From: Angela Jolliffe [REDACTED]
Sent: 27 January 2017 16:43
To: Hilary Kernohan; David Innes
Cc: Claire Potts
Subject: Redraw Pollards Nursery Site BN/66/16/DOC, BN/52/16/Res (51/16)

Further to my previous emails relating to the Redrow Application for a revised layout, please see below relating to the Reptile habitat.

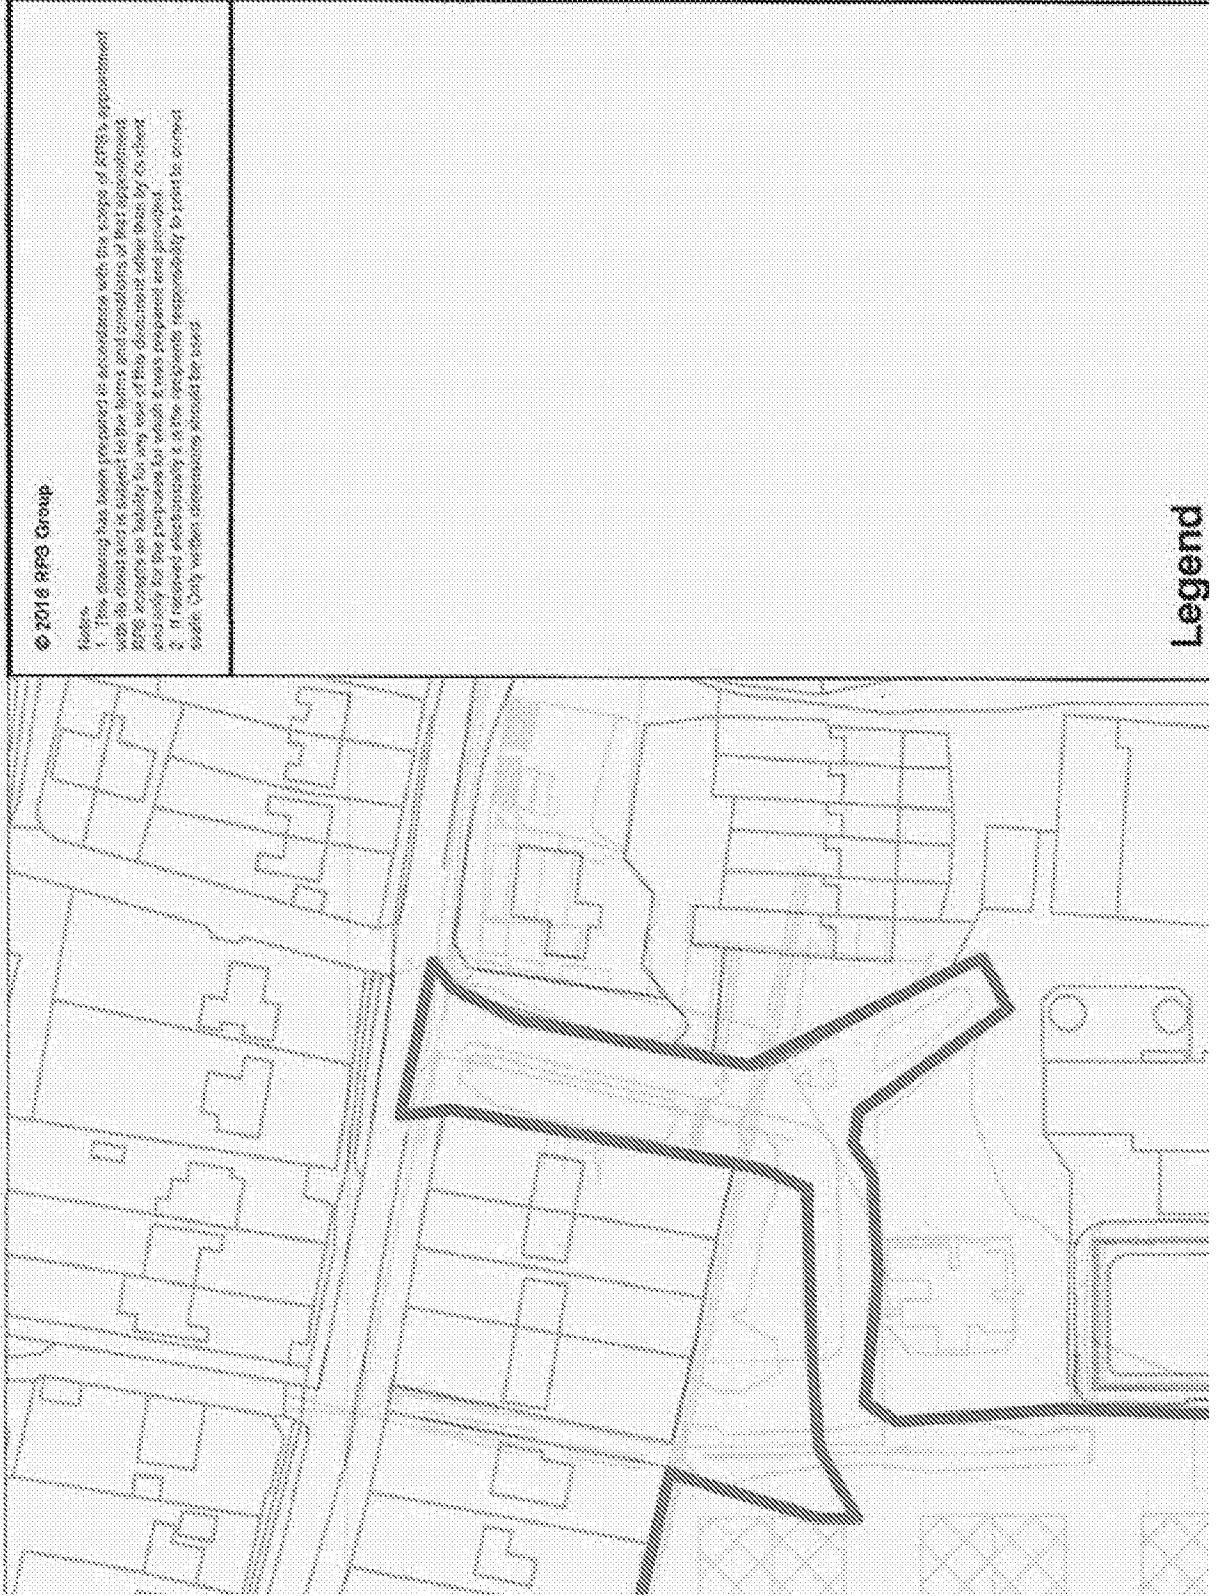
Redrow's plans, to scale, show hedging/greenary extending some 10-14 meters inside the Western boundary of their site. The attached plan shows the reptile habitat to be Retained along the western Boundary (including the substantial reptile habitat along the southern boundary which is to be removed).

Unfortunately, Redrows plan to build 4 houses dissects the Habitat to be retained along the Western Boundary in Figure 3 attached.

In addition the Highgate property they are proposing to build nearest the Western Boundary is 2.5 story. The light spill from this property will encroach on the 10m Bat Commuting and Foraging zone identified in my previous email.
